Appendix 4.3

Additional Scoping Consultation

Response to Environmental Impact Assessment Scoping Opinion: Reading Metropolitan

Town and Country Planning (Environmental Impact Assessment) Regulations 2017

PLATE 03 – RESULTS OF THE VOA ASSESSMENT SHOWING COMMERCIAL (RED) AND RESIDENTIAL (BLUE) USE CLASSES

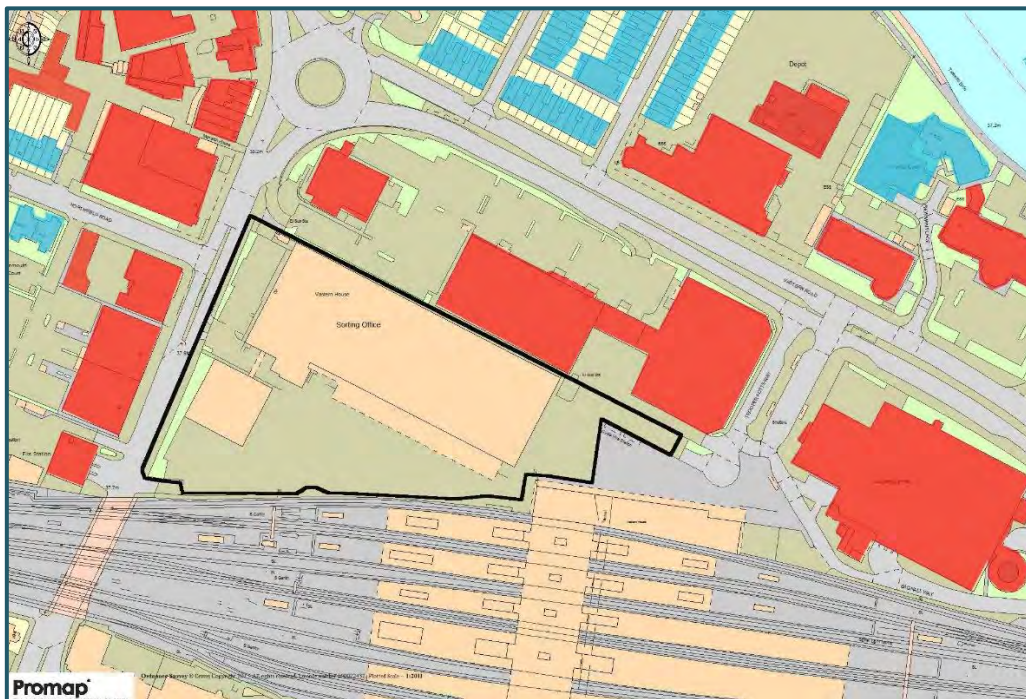
From a planning perspective, only those buildings which are residential or indeed have a residential component have been considered for the daylight and sunlight analysis. As a first pass, confirmation of the use classification of all neighbouring buildings has been secured by reference to a number of Valuation Office Agency (VOA) searches. Plate 03 confirms the use classification where commercial uses are shown in red and residential highlighted in blue.
